CITY OF DULUTH

File Number	PL 18-158	Contact	Kyle Deming, kdeming@duluthmn.gov	
Type	MU-I Planning Review	Planning Commission Date	January 8, 2019	
Deadline for Action	Application Date	December 4, 2018	60 Days	February 4, 2019
	Date Extension Letter Mailed	December 20, 2018	120 Days	April 3, 2019
Location of Subject	1012 E. Second St. (St. Luke's Building A)			
Applicant	St. Luke's Hospital – Mike Boeselager	Contact	mboeselager@slhduluth.com	
Agent	Erdman Company – Tim Casey	Contact	tcasey@erdman.com	
Legal Description	PID 010-3830-05080			
Site Visit Date	December 26, 2018	Sign Notice Date	December 24, 2018	
Neighbor Letter Date	December 21, 2018	Number of Letters Sent	69

Requested is a Plan Review associated with the MU-I plan for the St. Luke's Campus. The proposal includes:

St. Luke's Hospital
 1012 E. 2nd St.
 MU-I Plan Review
 Parking and Helistop

LANDSCAPING PLAN
ST. LUKES HOSPITAL

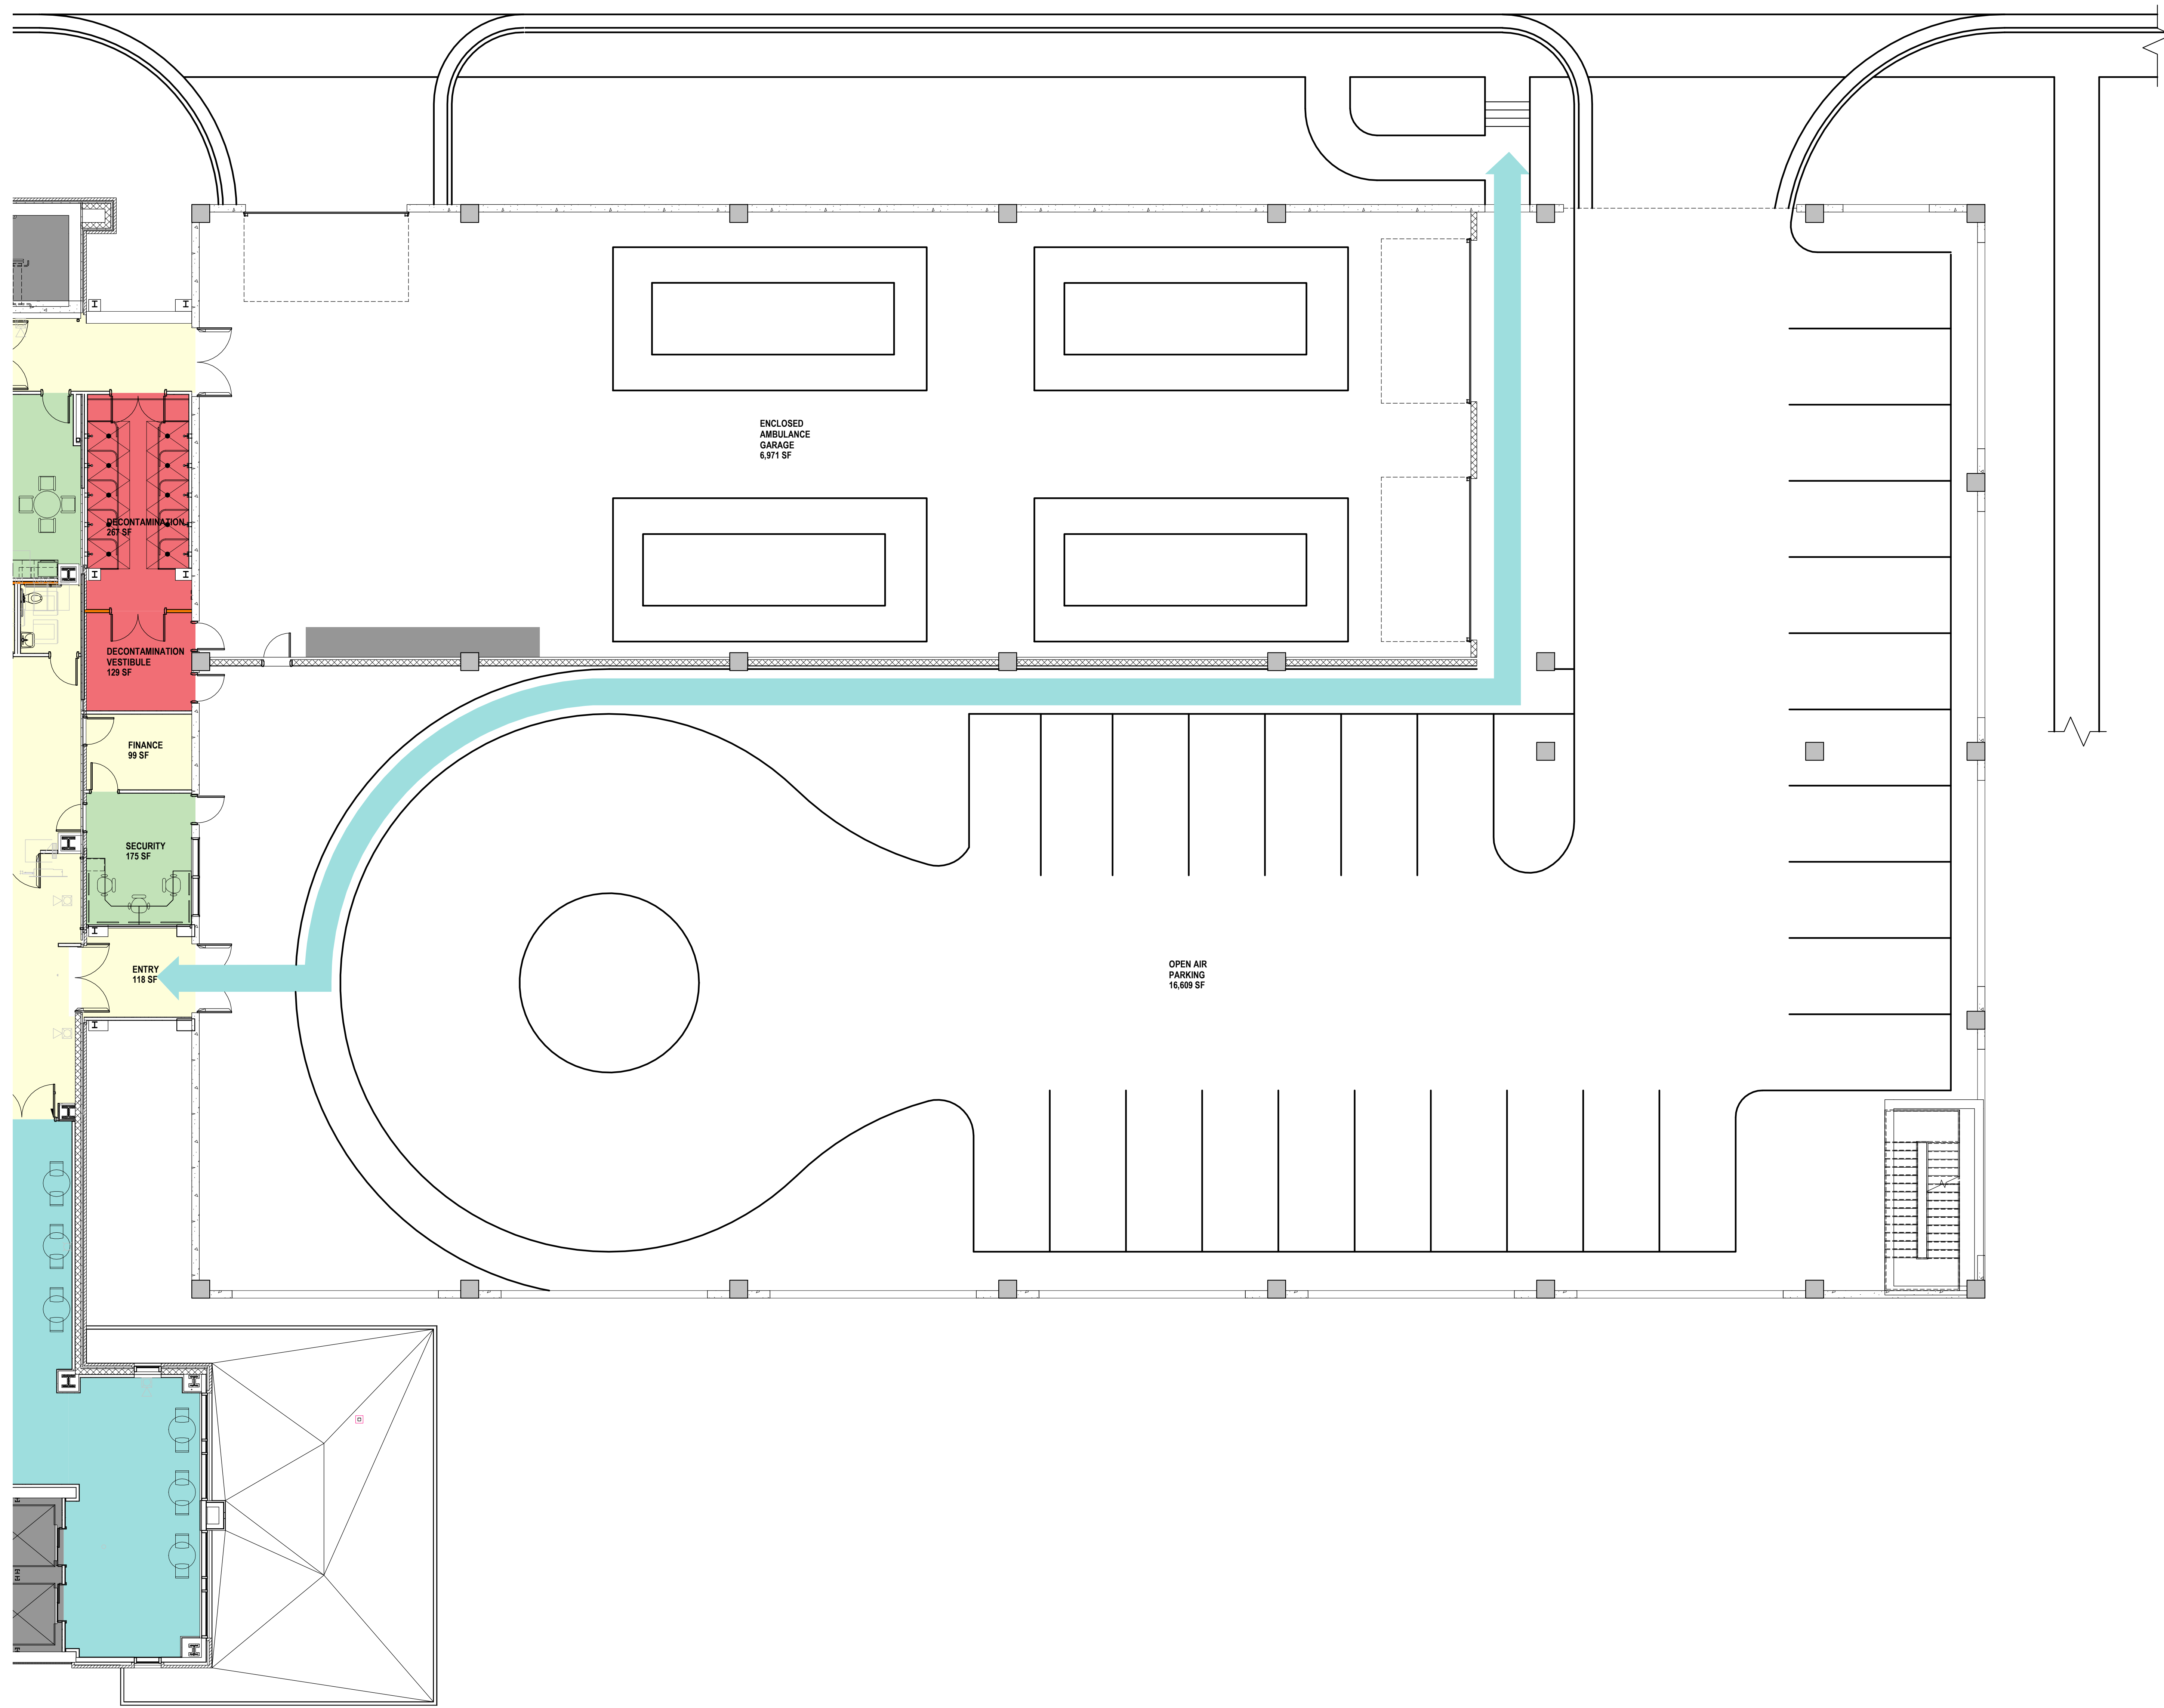
7) 50-25 (Landscaping and Tree Preservation) – Attachment C.3 is the landscape plan described by paragraph 14 of the applicant's submittal. The proposal provides required street frontage landscaping for the new structure as well as the improved parking lot on the north side of E. 2nd St.

- 4) The applicant provide to the Land Use Supervisor revised landscape and storm water plans (Attachments C.1, C.2, and C.3) before application for a building permit to show additional landscaping (street trees) that meet UDC requirements and storm water improvements to the parking lot on the north side of E. 2nd St. that are approved by the City Engineer;
